Change 3 - Addition of land for safe visibility and temporary alternative access to residential property

Change 2 - Western extension to safely accommodate overhead line works

Change 1 - Addition of land to accommodate Skylark and Curlew mitigation

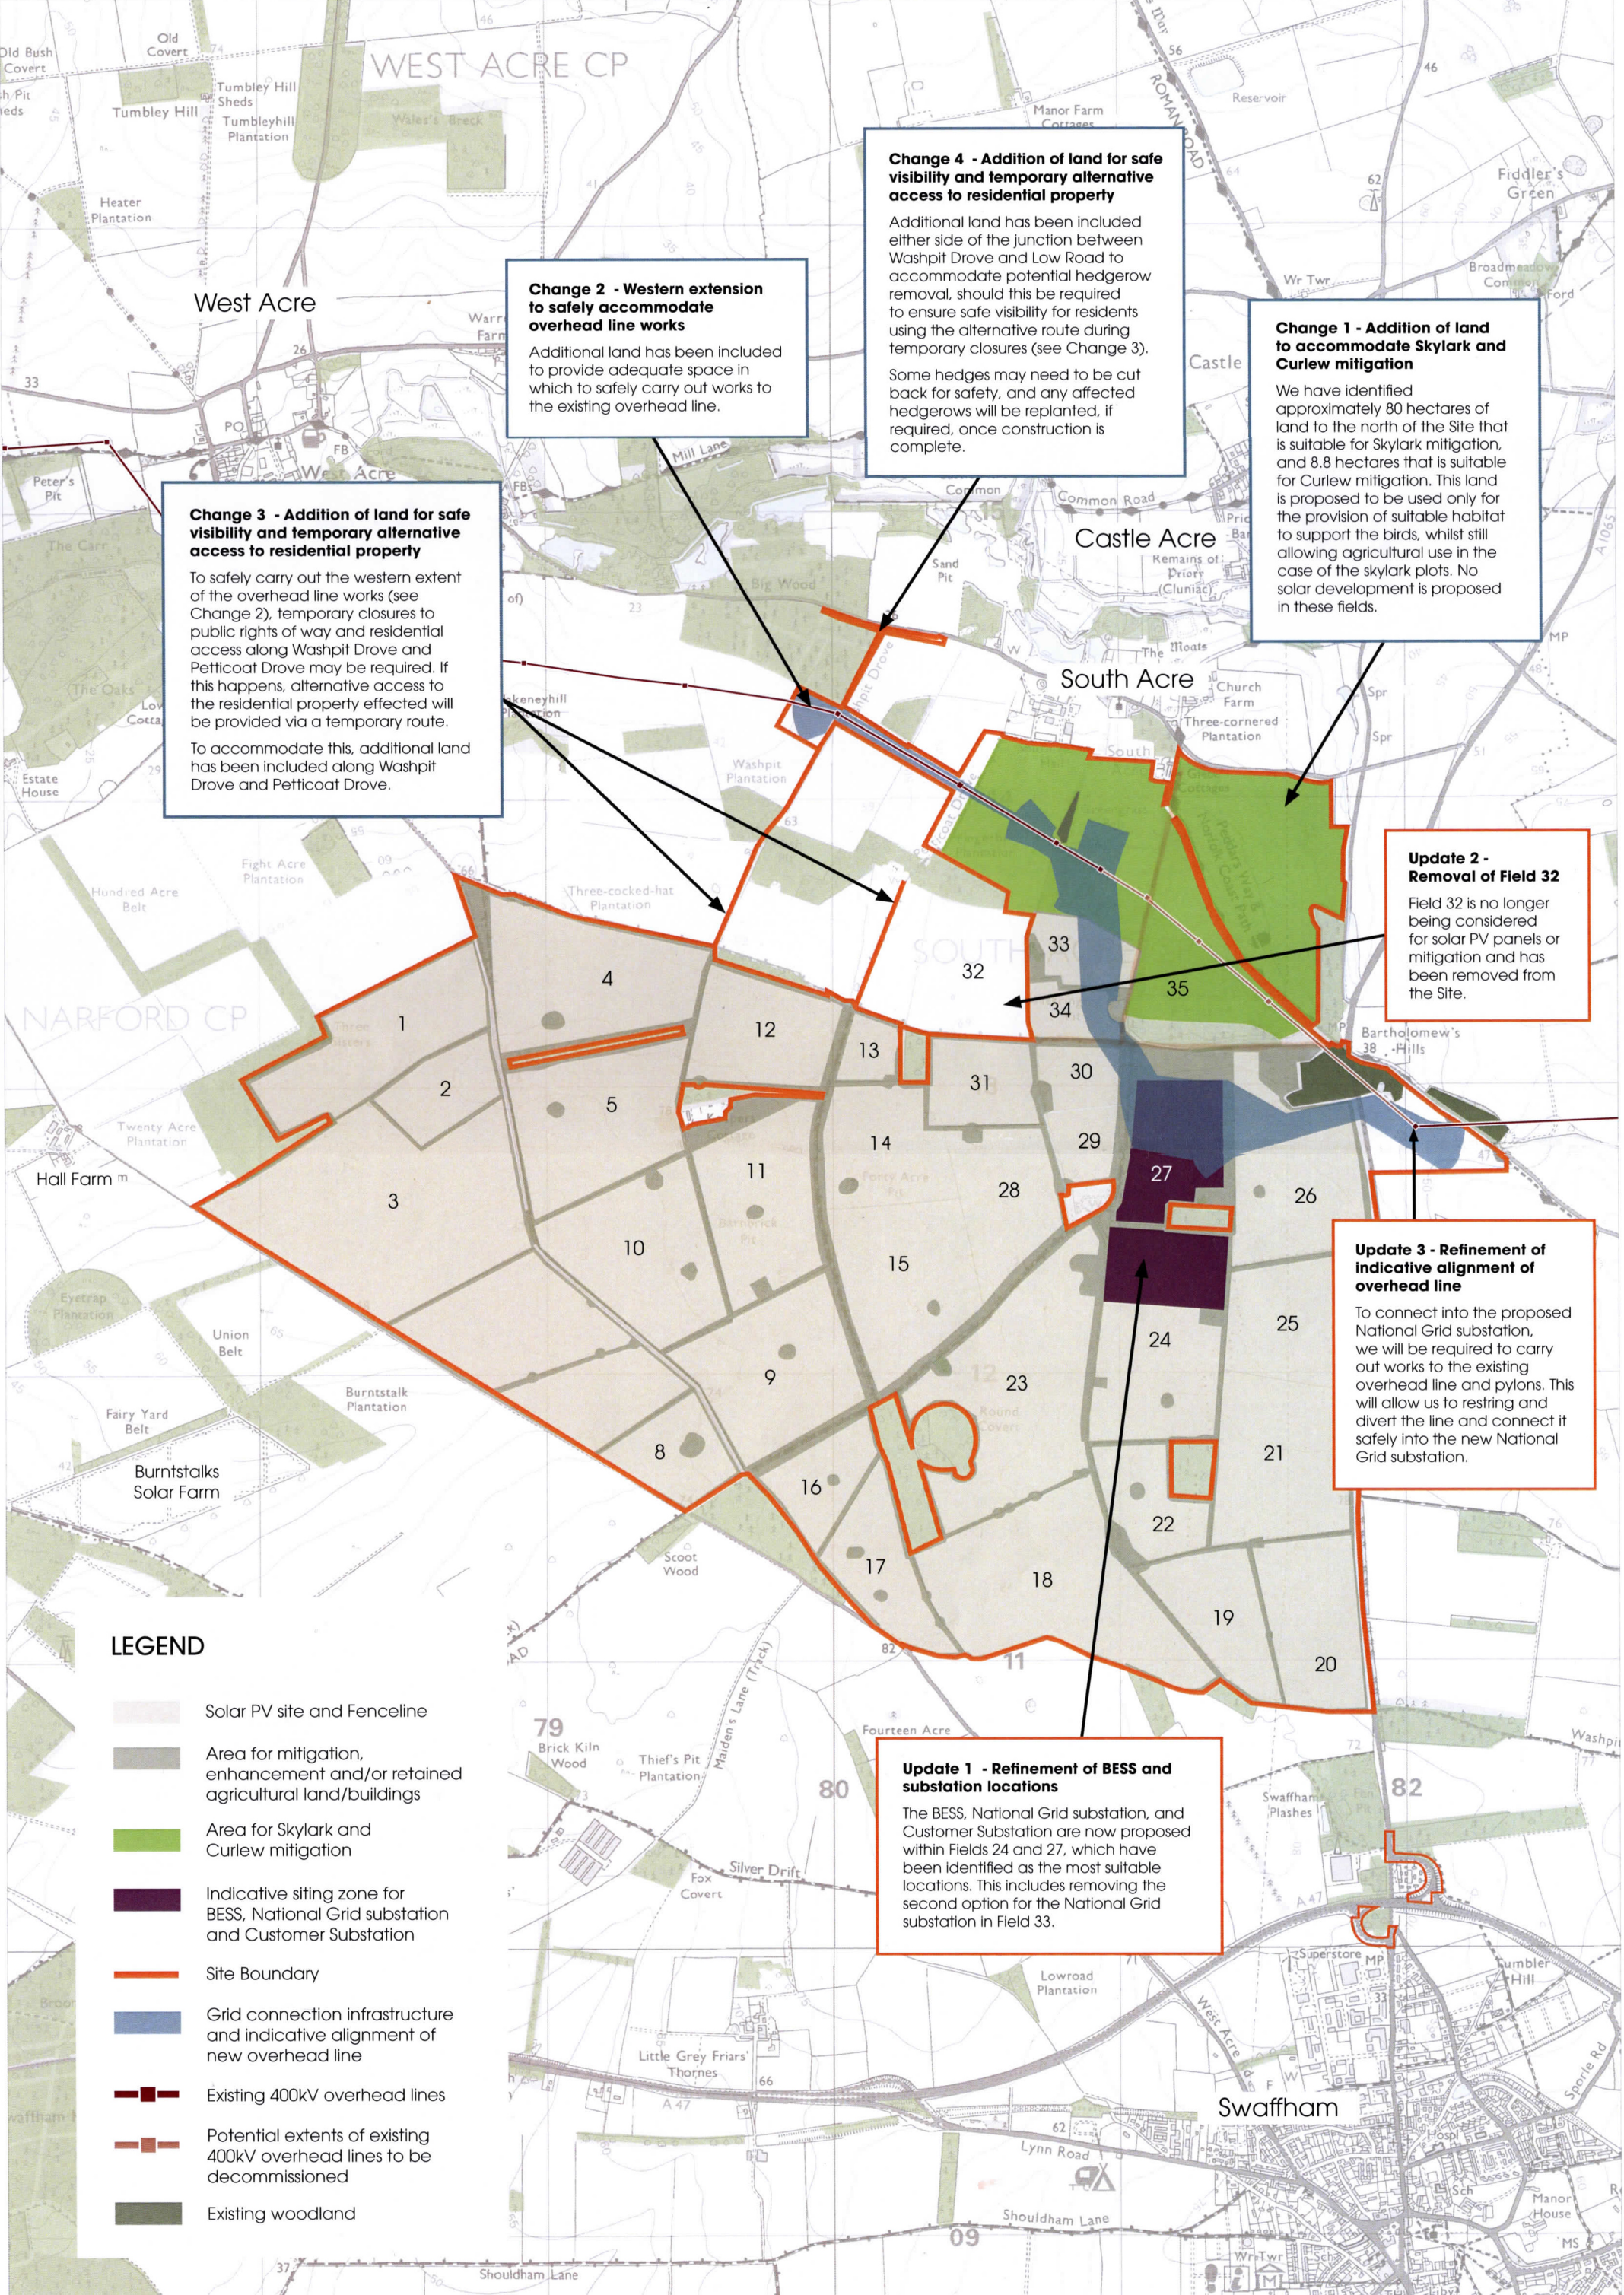
To safely carry out the western extent of the overhead line works (see Change 2), temporary closures to public rights of way and residential access along Washpit Drove and Petticoat Drove may be required. If this happens, alternative access to the residential property effected will be provided via a temporary route.

To accommodate this, additional land has been included along Washpit Drove and Petticoat Drove.

Additional land has been included to provide adequate space in which to safely carry out works to the existing overhead line.

Change 4 - Addition of land for safe visibility and temporary alternative access to residential property

Additional land has been included either side of the junction between Washpit Drove and Low Road to accommodate potential hedgerow removal, should this be required to ensure safe visibility for residents using the alternative route during temporary closures (see Change 3).

Some hedges may need to be cut back for safety, and any affected hedgerows will be replanted, if required, once construction is complete.

We have identified approximately 80 hectares of land to the north of the Site that is suitable for Skylark mitigation, and 8.8 hectares that is suitable for Curlew mitigation. This land is proposed to be used only for the provision of suitable habitat to support the birds, whilst still allowing agricultural use in the case of the skylark plots. No solar development is proposed in these fields.

Update 2 - Removal of Field 32

Field 32 is no longer being considered for solar PV panels or mitigation and has been removed from the Site.

Update 3 - Refinement of indicative alignment of overhead line

To connect into the proposed National Grid substation, we will be required to carry out works to the existing overhead line and pylons. This will allow us to restring and divert the line and connect it safely into the new National Grid substation.

Update 1 - Refinement of BESS and substation locations

The BESS, National Grid substation, and Customer Substation are now proposed within Fields 24 and 27, which have been identified as the most suitable locations. This includes removing the second option for the National Grid substation in Field 33.
